ADA Curb Ramp New Construction Inspection Form (Perpendicular)

Nw 288 ter

24952.54

Nw carver st

PERPENDICULAR RAMP (PR)

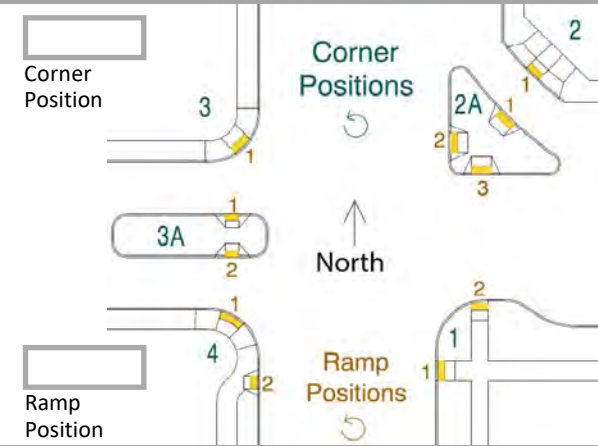
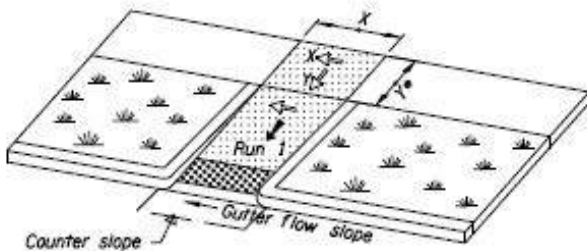
Too joints in turn space
